Subject: Arkansas Nuclear One - Unit 1
Docket No. 50-313
License No. DPR-51
Additional Information for 10CFR50 Appendix R
Exemption Request for Makeup Pump Rooms

Additional Information for ANO-1 Makeup Pump Rooms

Figure 2a -- MU Pump Rooms

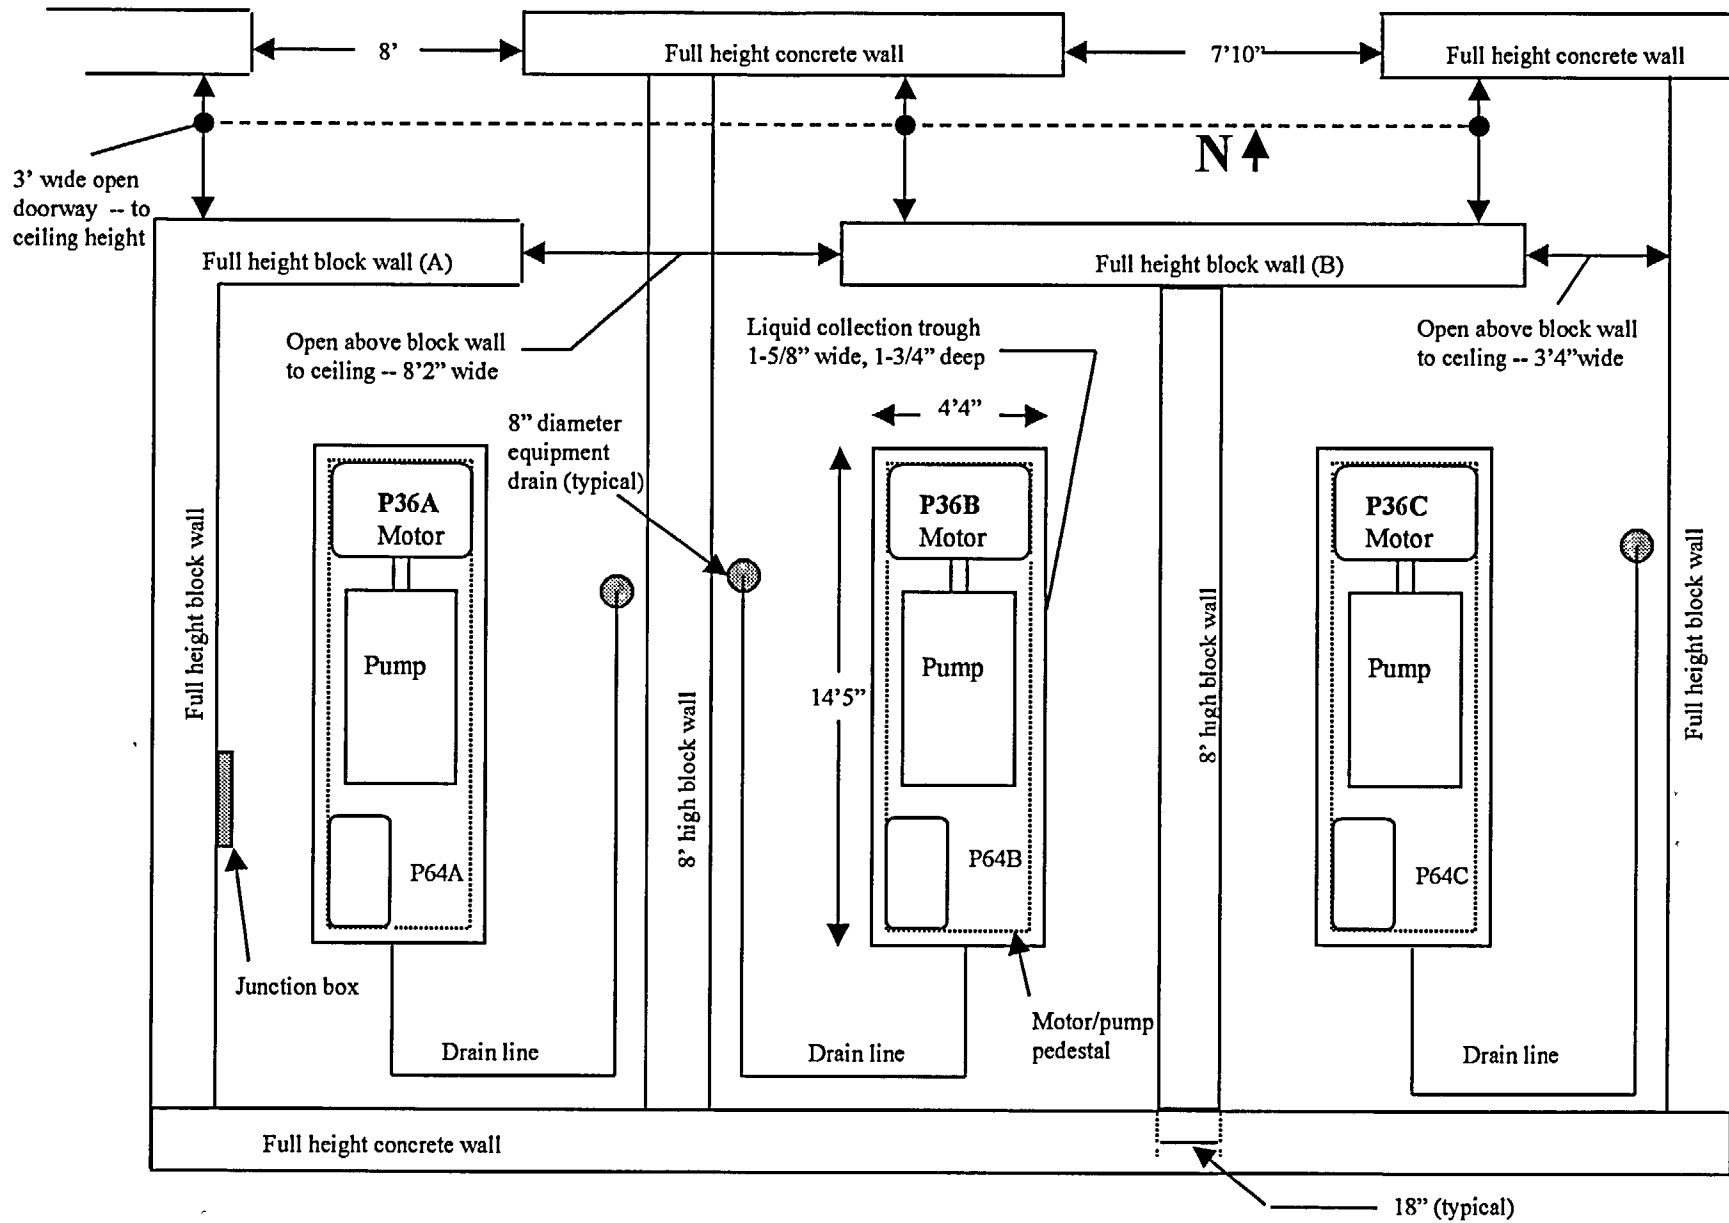
- The open doorways into the corridor are approximately eight feet in width and are eight feet high. Additionally, there are no doors on the full height block walls located immediately north of the makeup pump pedestals. Open doorways extend to the ceiling height. The distance between the north/south block walls and the full height block walls (i.e., Wall A and Wall B on Figure 2a) immediately north of the makeup pump pedestals is three feet four inches. The makeup pump room cubicle ceiling height is 16 feet 3 inches. Since the block wall separating the 'A' makeup pump cubicle from the 'B' makeup pump cubicle is only eight feet high, the opening above the partial height wall between Wall A and Wall B is eight feet two inches in width and eight feet three inches high (i.e., reaches the ceiling). In addition to the hot gas layer being dissipated into the corridor (i.e., once it descends to the eight foot high open doorways), there is a three foot wide open doorway (height extends to the ceiling) that opens into the tank room immediately west of the 'A' makeup pump cubicle.

- The CFAST model is set up with four compartments. A five compartment configuration may be more appropriate. As modeled, the 'vent' to the fourth compartment (from compartments 1, 2, and 3) is specified as four feet wide with a soffit eight feet from ceiling. However, the 'doorway' into the tank room does not have a soffit (i.e., open to ceiling). The 'doorway' into the radwaste corridor does have a soffit, but each of the two openings is approximately eight feet wide.

- The architectural drawings that depict elevation 335' are A-107 sheet 1 and C-299 sheets 1, 6, 7, and 8. From these drawings, the tank room (suggested compartment #4) is located west of the makeup pump cubicles and is estimated from drawings to be 35 feet 10 inches x 24 feet 4 inches. The ceiling height is consistent with that of the makeup pump cubicles (i.e., 16 feet 3 inches). As noted on Figure 2b, the opening into the tank room is three feet wide and has no soffit (i.e., opening is flush with ceiling). The tank room ceiling is concrete except for the west end of the room, which is open to the elevation above. For conservatism and to simplify the model, the vent from the tank room to the elevation above should be neglected.

- Immediately north of the makeup pump cubicles is a small hallway. The volume of this hallway can be neglected, but will add to the conservatism of the model. The hallway connects the makeup pump cubicles to the tank room (via the above discussed opening) and to the larger corridor/open area (suggested compartment #5) that contains various radwaste equipment. The open area is large and can be conservatively estimated to be 95 feet x 95 feet. There are two openings into the open area (one north of P36A and the other north of P36B/P36C). These openings are approximately eight feet in width and have an eight foot soffit.
